Re: 693 Sunnypoint Drive – Committee of Adjustment Application for Consent - Peer Review

As you have requested, Urban Forest Innovations, Inc. (UFI) has reviewed the arborist report and related application information submitted in support of an Application for Minor Variance - Relief from Zoning By-law 2010-40 for legalizing a new accessory structure (shed recently built in the backyard) at 693 Sunnypoint Drive, Newmarket, ON.

Figure 1: The new shed is located within the critical root zone of regulated tree #6.

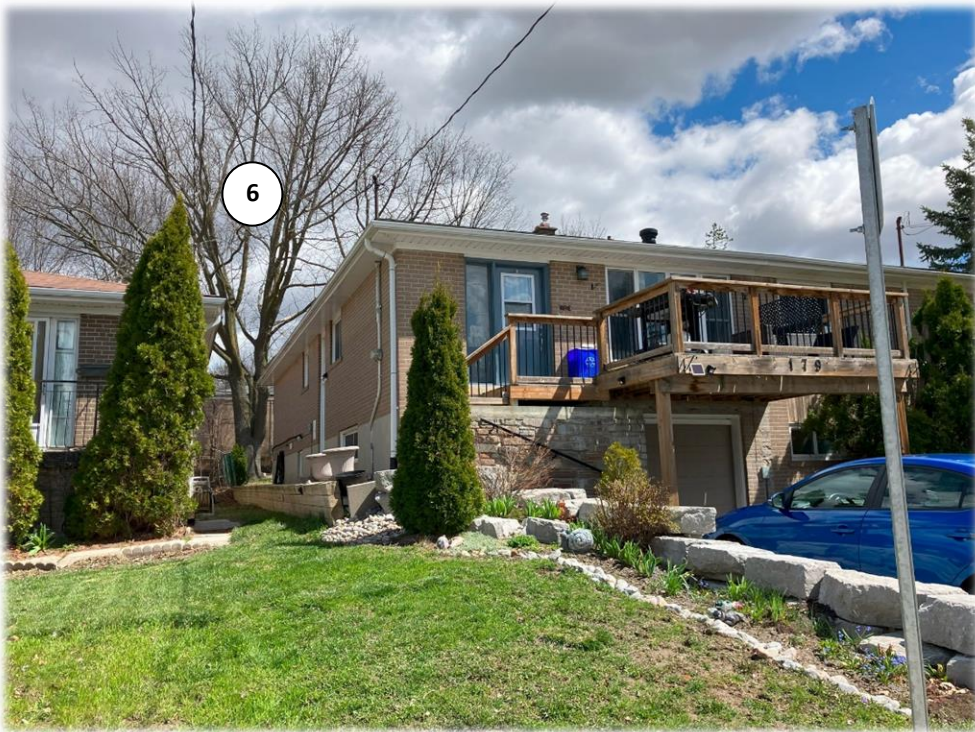
1. The root zone of by-law regulated tree #6 has been impacted by excavation to enable the installation of sonotubes for the new shed (Figure 1). Neither tree protection fencing nor root protection measures appear to have been undertaken during the shed construction (as documented on page 7-8 of the Arborist Report). The revised arborist report must identify appropriate tree injury amelioration measures to be undertaken post-construction and which will ensure the health and survival of tree #6. Refer to the *Policy* for appropriate measures.
